TRANS/WP.29/GRE/2002/45/Rev.1  
11 August 2003

World Forum for Harmonization of Vehicle Regulations (WP.29)

PROPOSAL FOR DRAFT AMENDMENTS TO DRAFT REGULATION ON  
ADAPTIVE FRONT-LIGHTING SYSTEM (AFS)

Transmitted by the expert from Poland

"Figure 1: Position of passing beam photometric requirements on the road surface (RS) for class C, V, W, E.

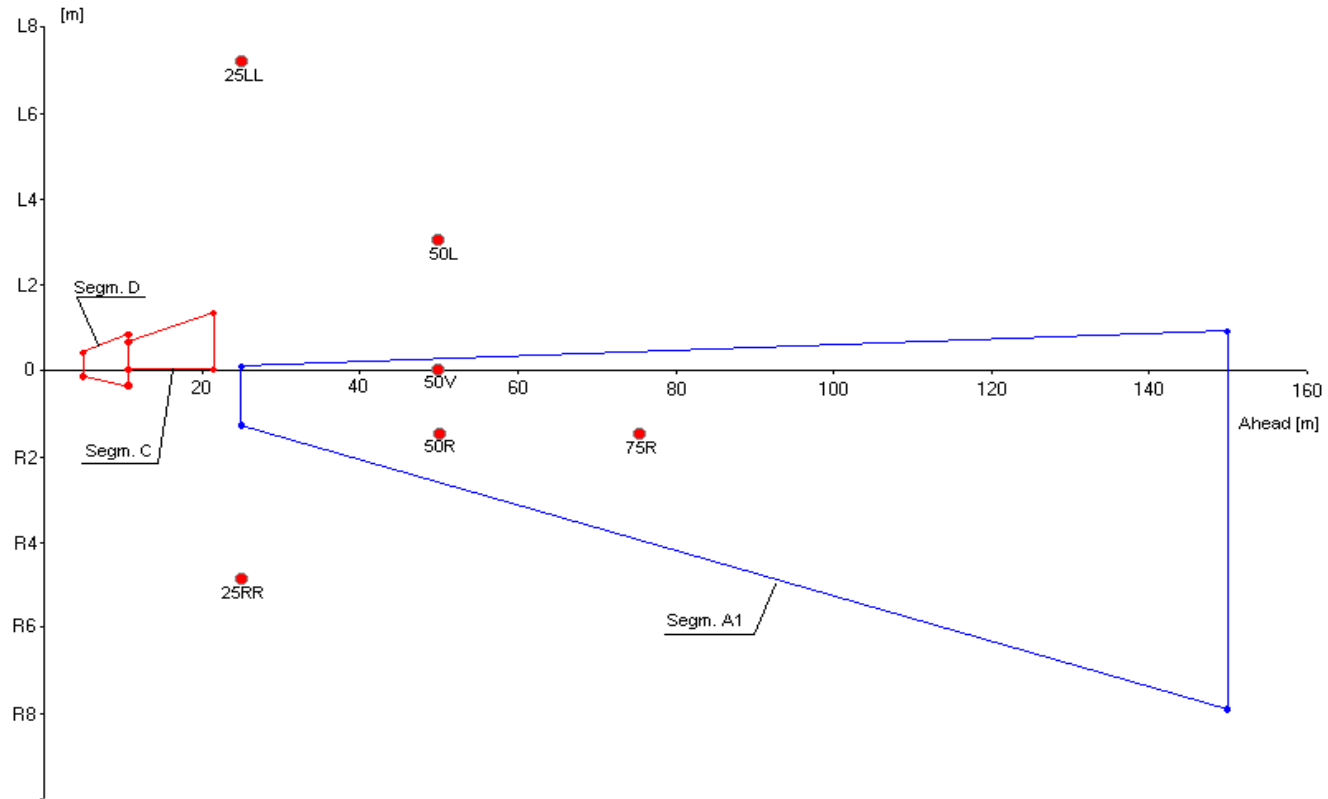
Insert new figures 1, 2 and 3 and tables 1, 1a to 1d, to read: (see next pages).

Fig. 1. View of vertical intersection of present and proposed co-ordinates systems.

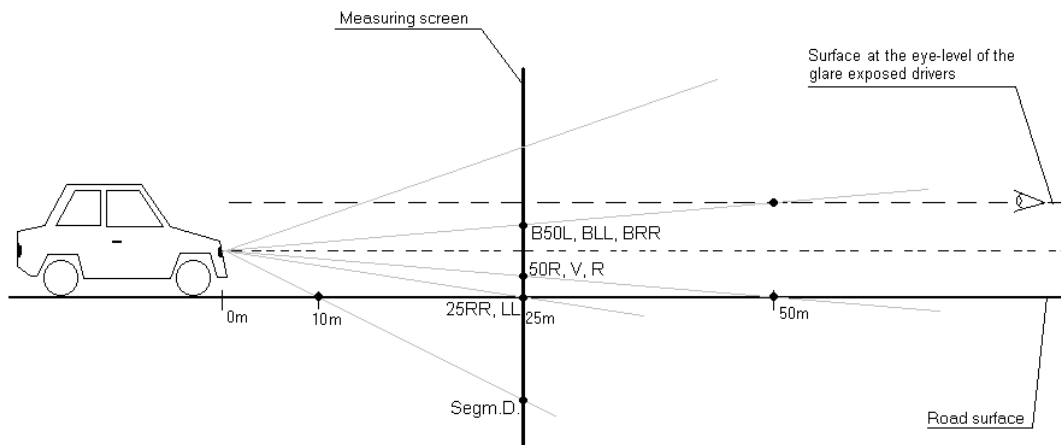
It is proposed to express photometric requirements for two separate surfaces: road surface (RS) and surface at the eye-level of the glare exposed drivers (GS) which are equivalent to those proposed in Draft XXX Regulation: RS – bottom part of the screen, GS – top part of the screen. The RS and GS co-ordinate system has a significant advantage: it describes the whole system performance independently of the number of lighting units and their locations.
